Part Change Notice

Re: KDMIX-FS1V-WS-B, KDMIX-FS1V-WS-B30

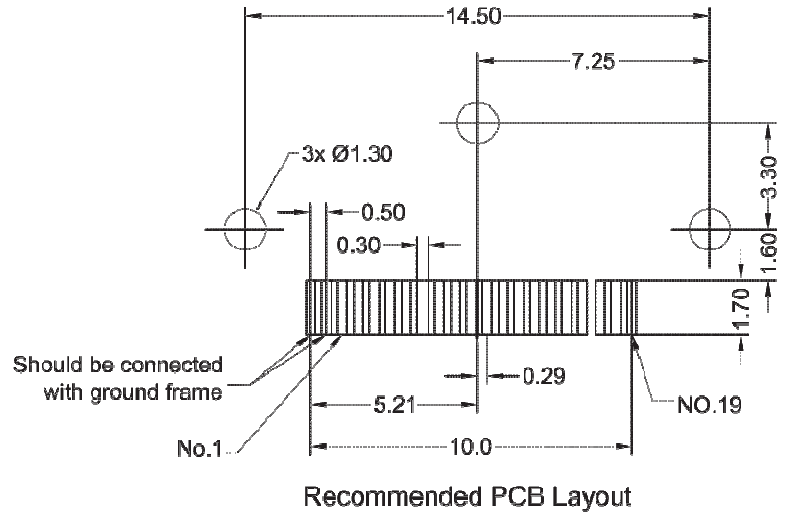
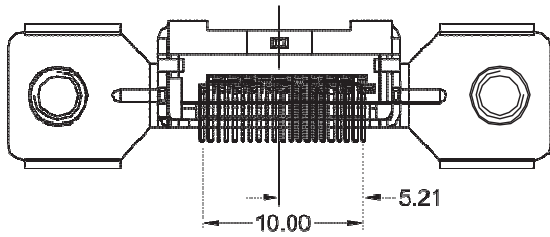
Due to a possible patent issue with the part numbers above, we have made some modifications to our parts. The two dummy pegs have been removed. Please see the illustration below indicating the changes to the part. The function remains the same.
